DESIGN REVIEW BOARD RECOMMENDATION MEETING | CAPITOL HILL TOD

SECOND EAST DESIGN REVIEW BOARD MEETING ON OCTOBER 11, 2017

FIRST RECOMMENDATION MEETING PRIORITIES & BOARD RECOMMENDATIONS

RECOMMENDATION 2 | EAST ELEVATION

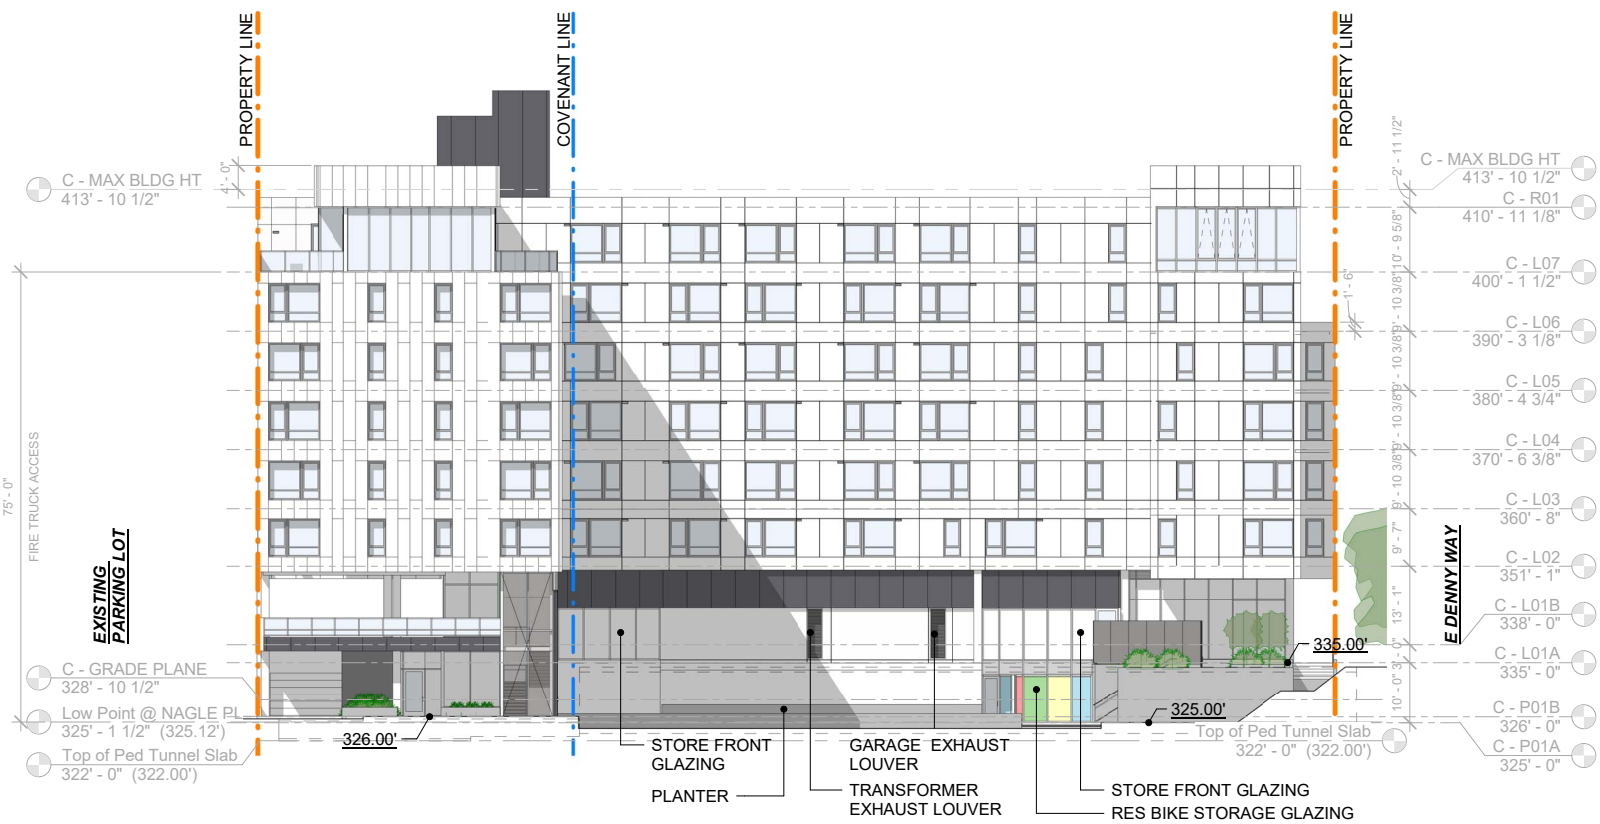
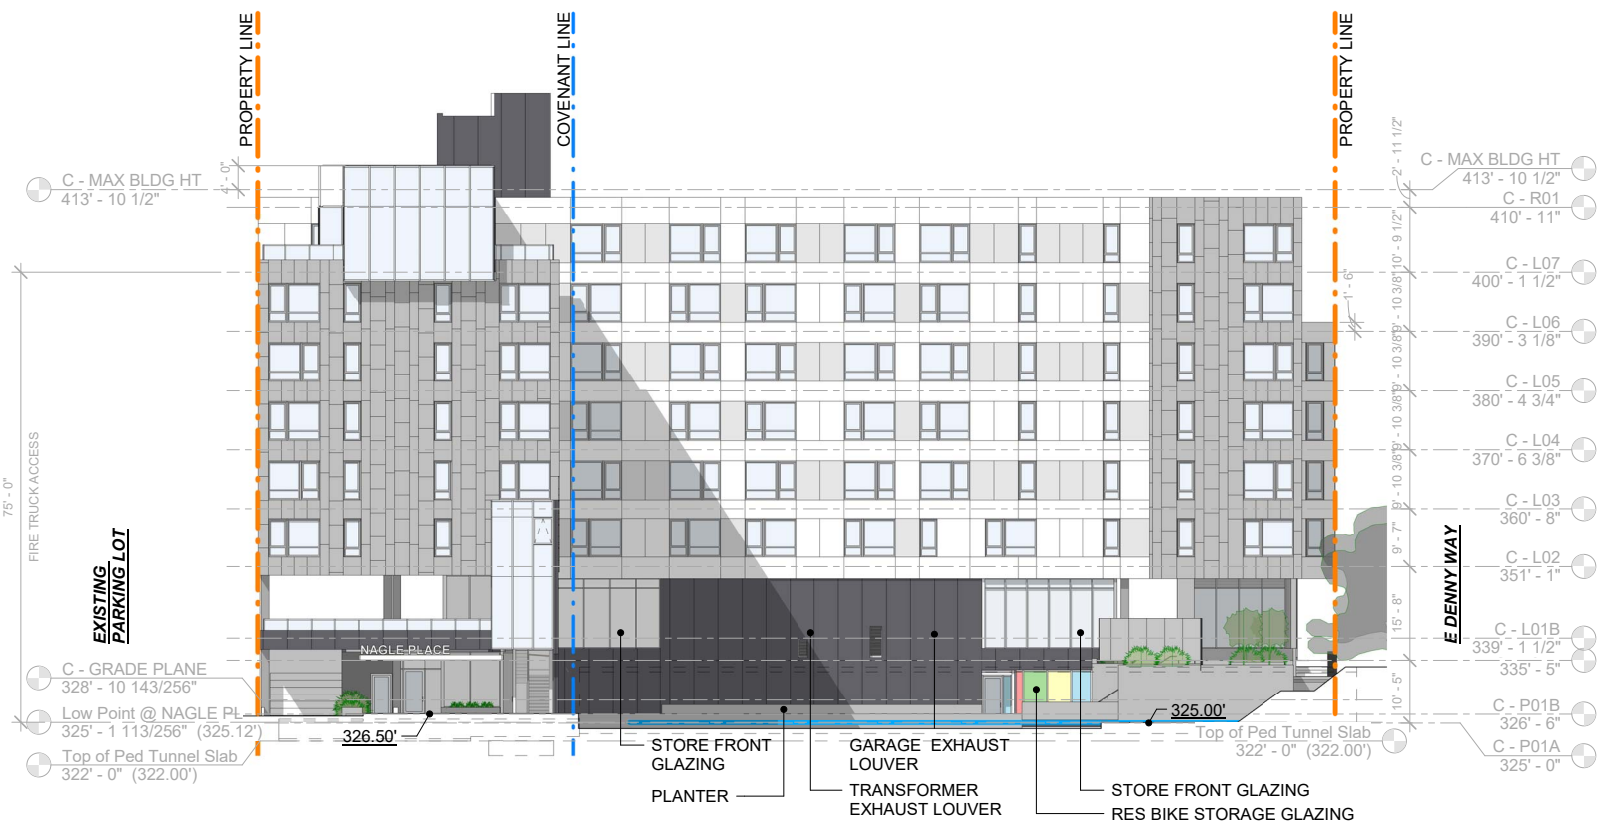
3) The Board noted that the east elevation that serves as a visible backdrop to the headhouse should be treated similarly to the west elevation in terms of visual interest and modulation. (DC2-S-I)

White accent panels with a high gloss reflective finish have been added to the east elevation between the amenity “lantern” and the bay at the north facade. An “A-B-A” pattern to these accent panels matches the west elevation on Broadway. The cladding on the bay at the north end replaces the through colored white concrete panels with the same anodized aluminium cladding proposed for the amenity “lantern.”

② RECOMMENDATION 2 | PLAN AT “LANTERN” ON BROADWAY

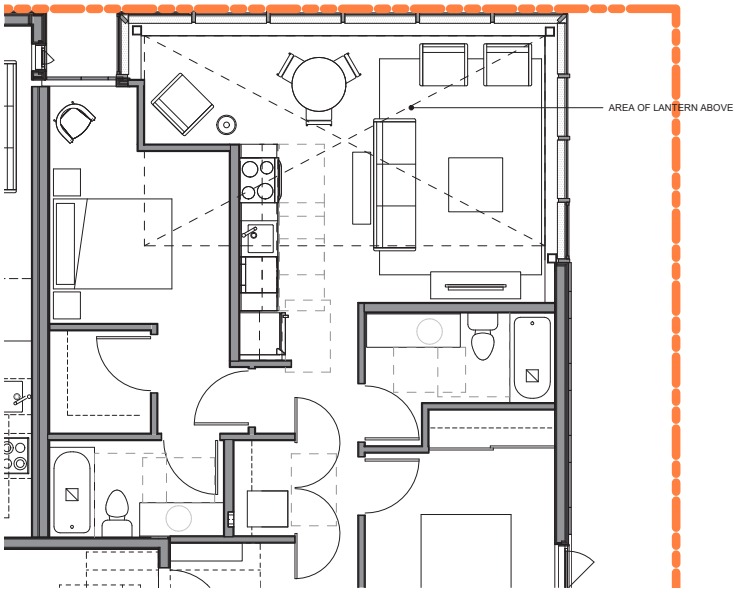
2) The Board was concerned that the effect of the “lantern” elements were not fully realized and should be expressed further to create strong focal points and create a strong architectural concept for the buildings along Broadway. These lantern elements should read as glassy boxes that have a higher proportion of glazing to allow them to better read as lit beacon elements. Specifically, the cap/parapet proportion is too heavy and should appear lighter and glassier. Resolution of this design element will better reinforce the contemporary, shifting and subtractive language shown at EDG at the Broadway building corners, midblock, tall ground floors, and expressing the upper setbacks and lanterns [199, 131]. (DC2-C & D; DC2-S-V-iii) See also Building A.

RESPONSE:
Similar to Building A, a curtain wall “upper northwest lantern” element is proposed. Due to the massing, rather than setting the “lantern” back from the face of the facade, as proposed on Building A, the lantern at the corner of E Denny and Broadway Ave is projected outward to align with the face of the building’s facade below with a recess wrapping around it. This creates a distinct, but similar lantern on Building C.

① RECOMMENDATION 2 | DETAIL AT LEVEL 07 "UPPER LANTERN ELEMENT" ON NAGLE PLACE
(NOTE: ALL DETAILS TO BE USED FOR DESIGN CONCEPT ONLY)

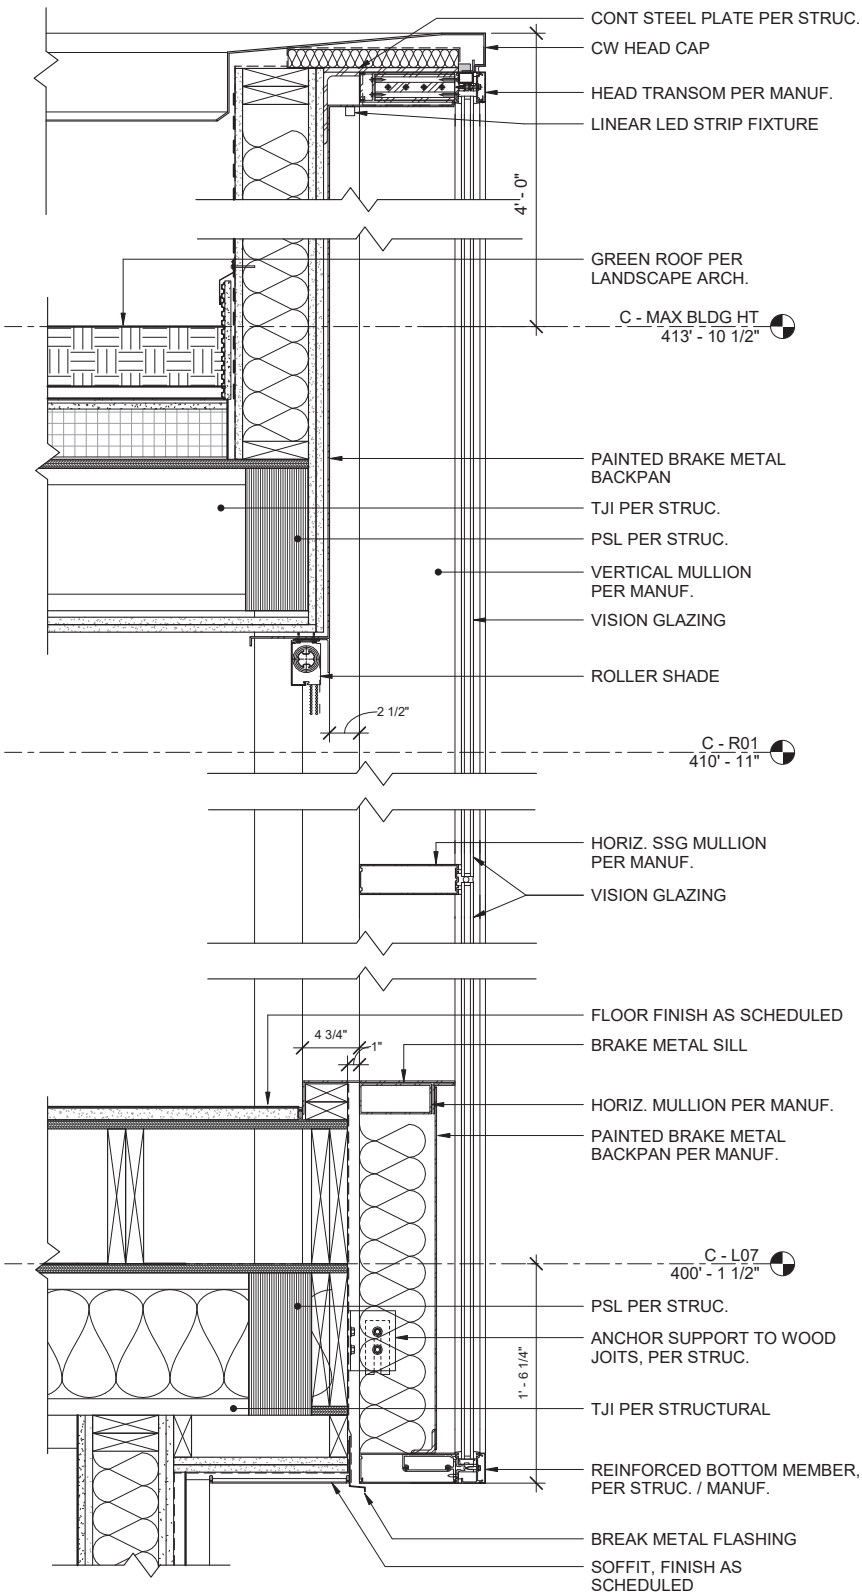
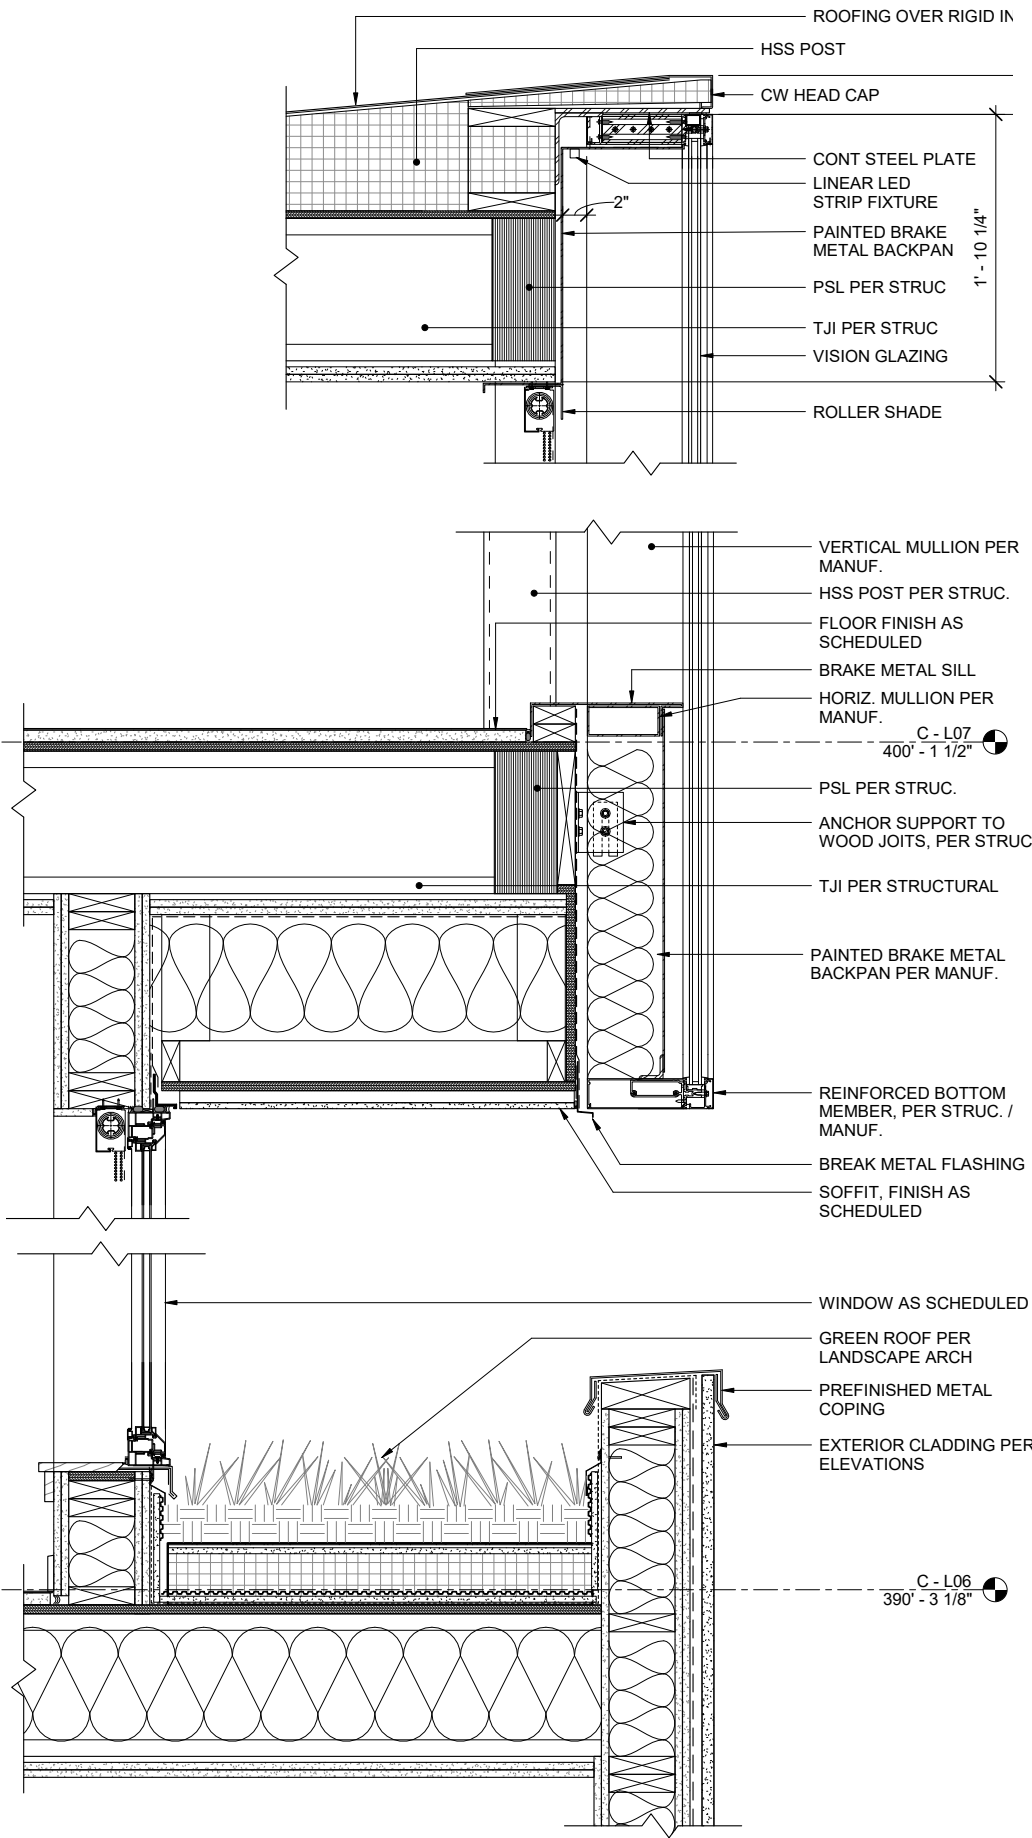
2) The Board was concerned that the effect of the "lantern" elements were not fully realized and should be expressed further to create strong focal points and create a strong architectural concept for the buildings along Broadway. These lantern elements should read as glassy boxes that have a higher proportion of glazing to allow them to better read as lit beacon elements. Specifically, the cap/parapet proportion is too heavy and should appear lighter and glassier. Resolution of this design element will better reinforce the contemporary, shifting and subtractive language shown at EDG at the Broadway building corners, midblock, tall ground floors, and expressing the upper setbacks and lanterns [199, 131]. (DC2-C & D; DC2-S-V-iii) See also Building A.

RESPONSE:
The level L07 "lantern" element at the common amenity room and the "lantern" at the stairwell on Nagle Place have been "amplified."

RECOMMENDATION 2 | LEVEL L01

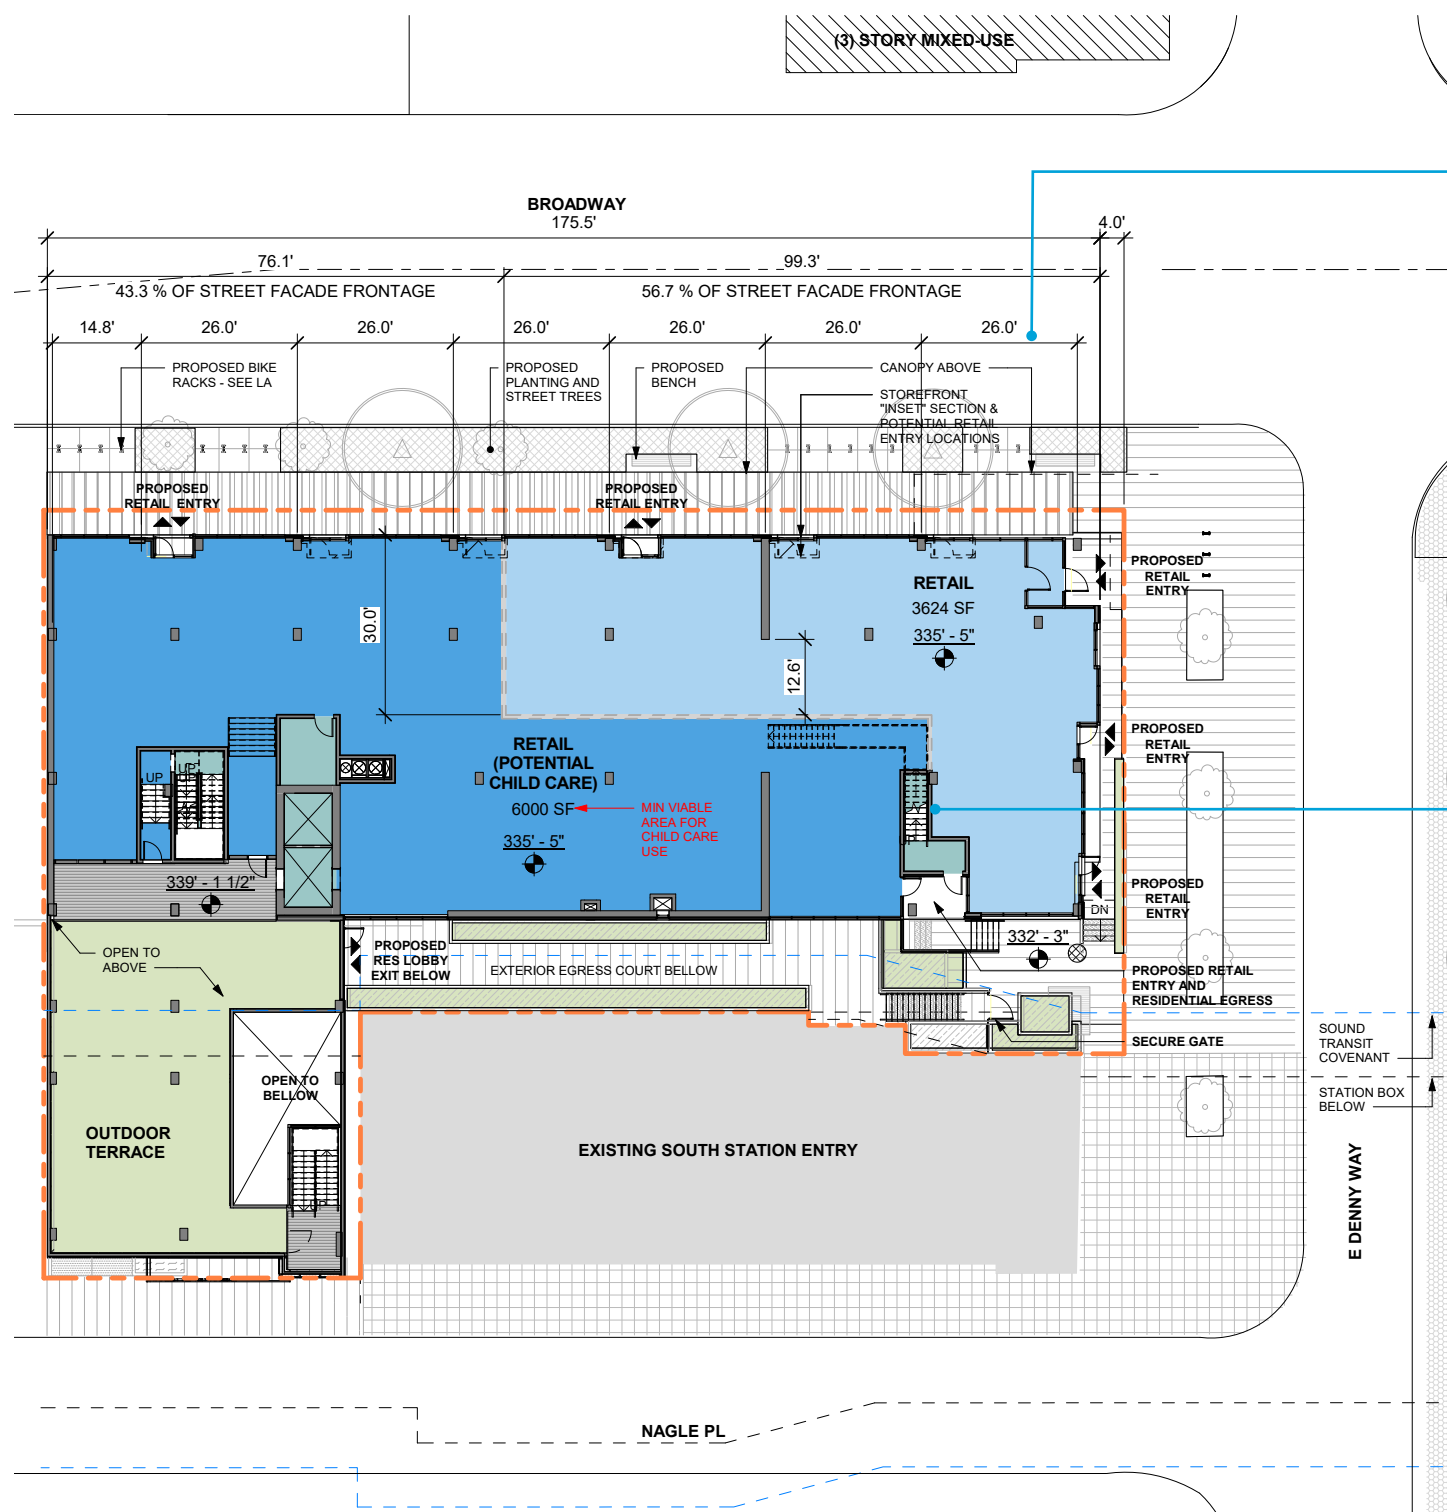
1) The Board continued to have concerns with the future potential lack of street activation of the proposed daycare use on Broadway. They recommended further minimizing this frontage and would support a departure from the commercial depth standards to help achieve this frontage activation issue. (CS2-S-I; PL3-C-1, PL3-C-2, PL3-I-iii)

RESPONSE:
To address street activation at the street level since Recommendation meeting #1 The proposal has:
